Planning Commission Meeting Agenda

1. East Peak 8 Hotel (CK) PL-2018-0576; 1599 Ski Hill Road 6

Planning Commission Staff Report

SHEET
 MAXIMUM HEIGHT
 DIAGRAM

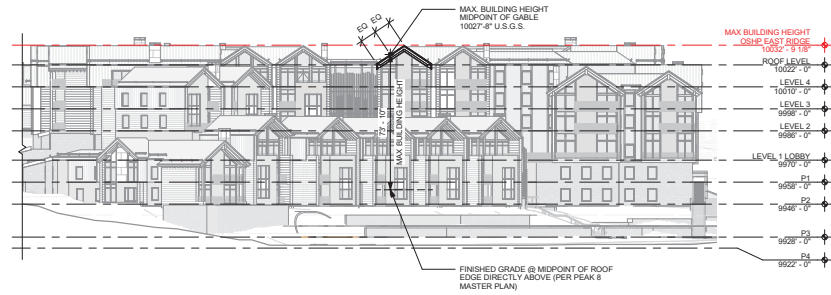
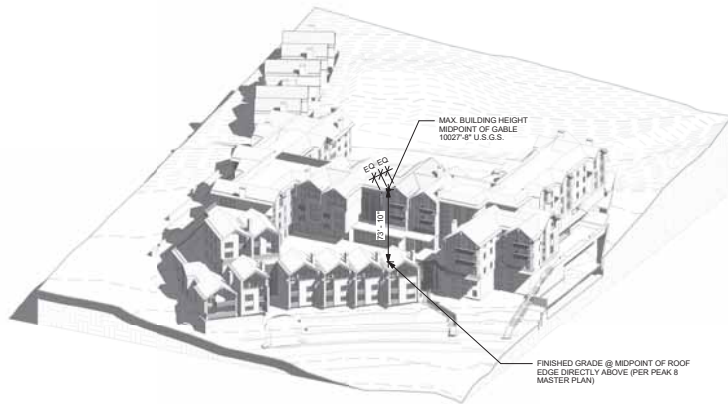
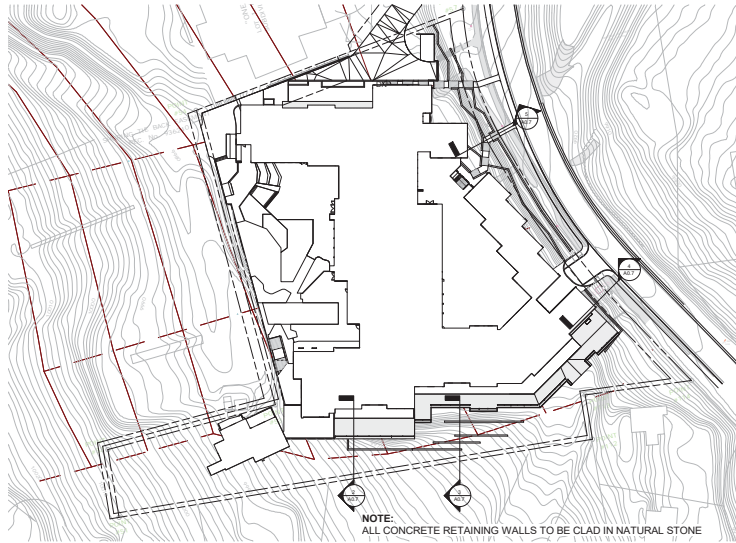
- **Mass (4/R & 4/R):** The proposed mass complies with the Master Plan and Development Agreement.
- **Building Height (6/A & 6/R):**
 - The height of the tallest portion of this building is 73' 10", as illustrated on the "Maximum Height Diagram", sheet A0.6, measured from the mean to the finished grade below. This exceeds the building height recommended in the land use guidelines by more than one-half ($\frac{1}{2}$) story but less than one story. This warrants negative (-10) ten points under Policy 6/R: Building Height.

- At its longest point, the project has an unbroken ridgeline of 73', this warrants negative (-1) one point.
 - The project does not technically exceed the east cross gable height in USGS of One Ski Hill Place (OSHP). The proposed height of the building adheres to the Development Agreement, Master Plan, Development Code and Land Use Guidelines. Staff notes that the USGS height of the OSHP east cross gable is only 1/8 inch higher than the five tallest ridgeline heights of the proposed East Peak 8 Hotel. This leaves no room for error and staff has some concerns about the ability to execute this plan in the field as measured to the top of ridge/ top of architectural shingle.
